# Land at Ford Airfield, Ford, West Sussex

## RM4 (F/16/24/RES)

Design Advisor Response, 01.11.2024

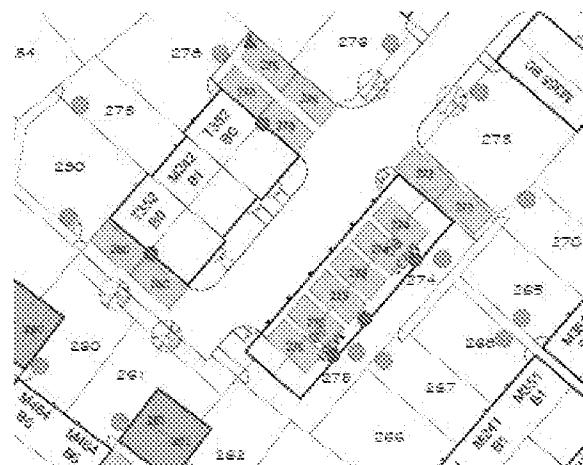
Ideally, the tertiary road would continue south up to the boundary. It is understood why this splits to create an additional frontage and row of units. However, in doing so, it creates a tight double bend for residents of the north-south mews streets and a more expansive area without a dedicated footpath. The arrangement also requires heavier service vehicles to use the narrow, paved mews streets in order to access the pumping station.

From a design perspective, it is recommended to at least upgrade the western mews to be a tertiary road with a dedicated footpath and a raised table at the end. The access to the pumping station could then be realigned to the tertiary road and the pumping station repositioned behind the building line to conceal a view of this.

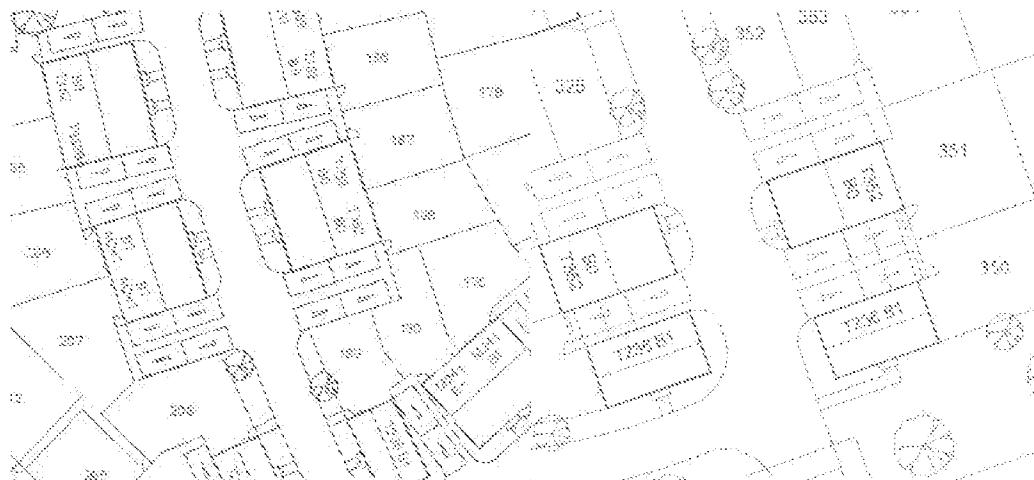
3.12. In the below area, front-to-front distances are a very minimal 8m – and, while noting the objective of creating passive surveillance in rear parking courts, in this instance, there is a concern that the occupants of the adjacent units will be frequently disturbed by the sight and sound of parking vehicles – particularly headlights into living rooms.

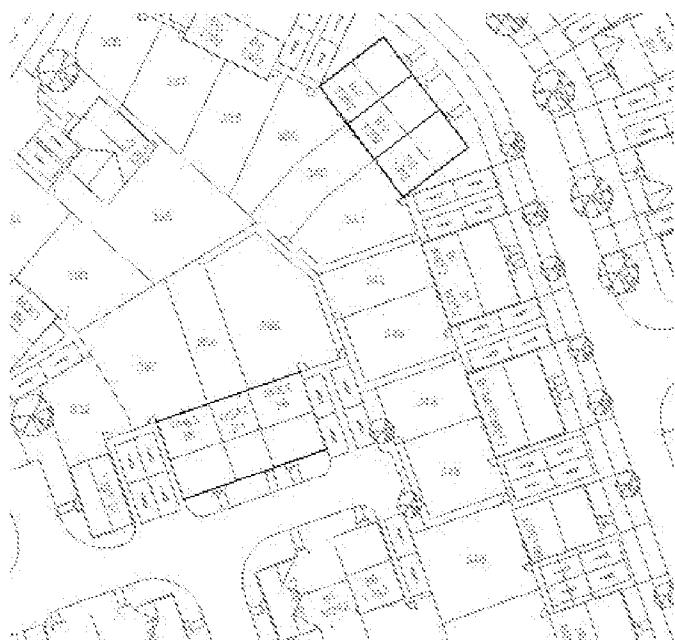
3.14. It is also noted that the ROW of the mews streets varies – although marginally – between 4.8m and 5m. Again, if the objective is for a less formal character, there is a need for greater variety in the building, eaves and ridge lines. Otherwise, it will be important to retain continuity in the ROW of the carriageway (despite the wider ROW being preferred).

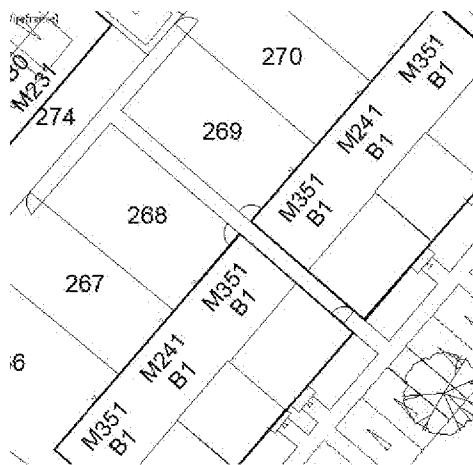
3.15. In general, the area to the east of the neighbourhood park looks particularly congested.

This creates:

- overlapping passageways (that will appear unusual and quite urban when fenced),
- a long, narrow garden for plot 356 with a 37m travel distance to the bin collection point (max. 15m according to the DC) and,
- reduced resident's parking for the 4-bed types.

Also, ideally, a 2-bed type would not be located between two no. 4-beds, while 4-bed terraced properties are uncommon.

Overall, the arrangement is a further indication of development intensity, where removing the 2-bed in the middle would release enough space to resolve each of these aspects. The value of two detached/ semi-detached 4-bed properties is also likely to balance the value of three terraced types with privacy strips and reduced parking provision.

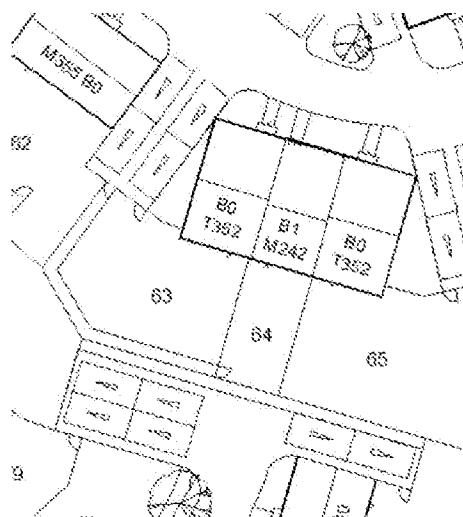
3.17. In some locations, the drag distance exceeds the 15m minimum and it is unclear where bins would be placed for collection other than across the path or the neighbour's privacy strip (DC notes that temporary collection points shall be located to prevent bins from blocking footpaths or the highway).

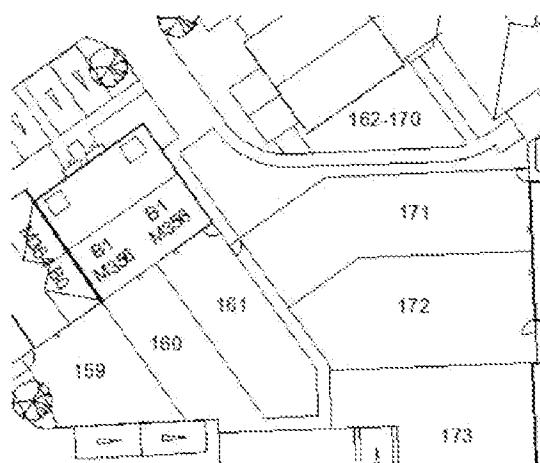
3.18. Generally, this occurs when providing rear access for mid-terrace units, particularly when, in the following case, the neighbouring unit has a wider garden. For instance, in the following configuration, the drag distance is approximately 35m. Bins would then need to be placed in a line between parking or across parking bays.

3.19. In the previous arrangement, a second passageway and fence line appear to be provided at the rear of plots 63, 64 and 65.

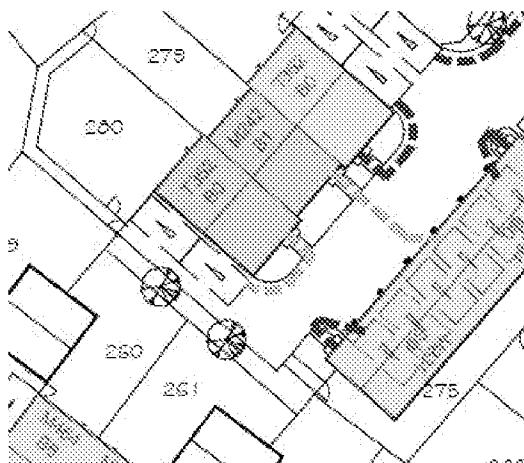
3.20. Similarly, in the below arrangement, the drag distance for plot 160 is approximately 33m, and the communal bin store is approximately 30m from the street.

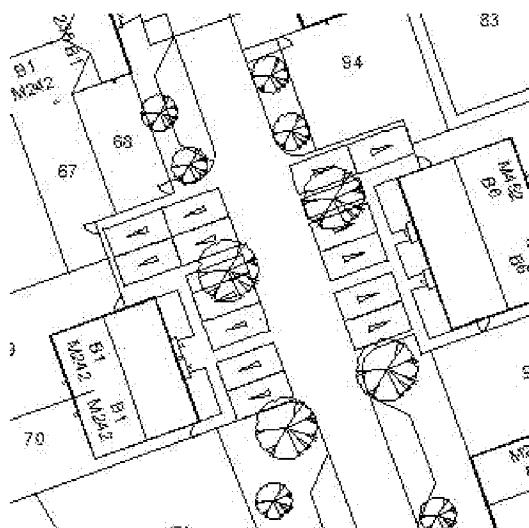
3.21. It is unclear why the end of the gardens of plots 260 and 261 have been removed – see below:

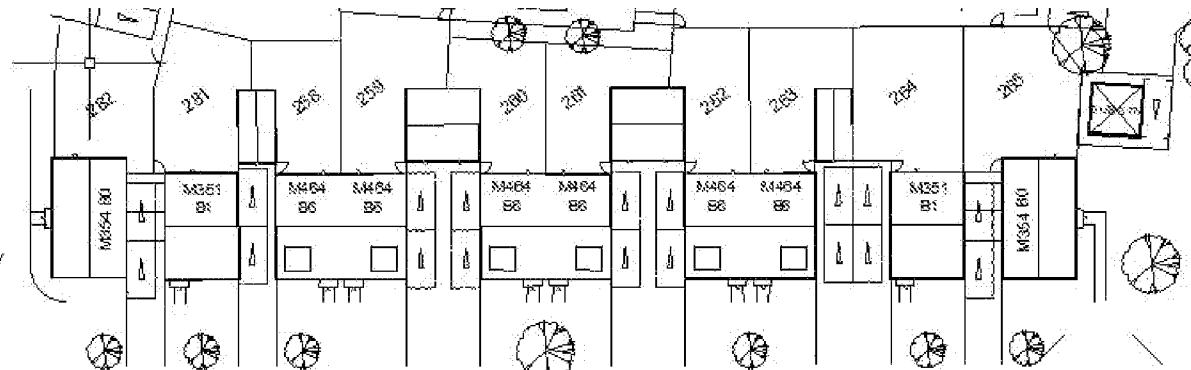
3.22. In the two instances of the following configuration, the units are in danger of being lost behind parking spaces. The impact is less apparent in the third mews street in the row – so, the situation presents when an additional two spaces for a further unit are provided. The congestion is more apparent through the amount of paths and fencing, which, while efficiently arranged, are beginning to look quite tight and urban.

This is another indication of development intensity, where splitting the row of terraces on the perpendicular street would allow on-plot parking for plot 67, thereby reducing the need for (and impact of) parking along the mews.

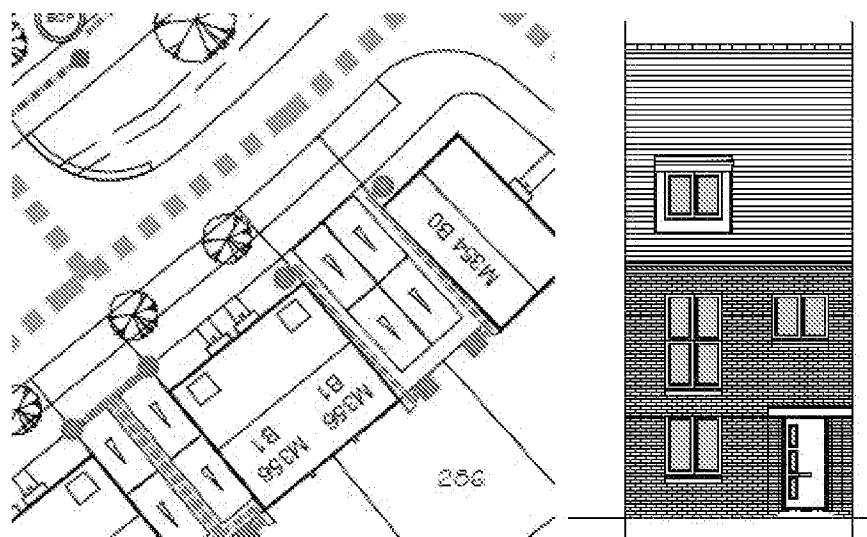
3.23. The frequency of garages is increasing the overall sense of enclosure where, along some street sections, there is no openness between garages and units.
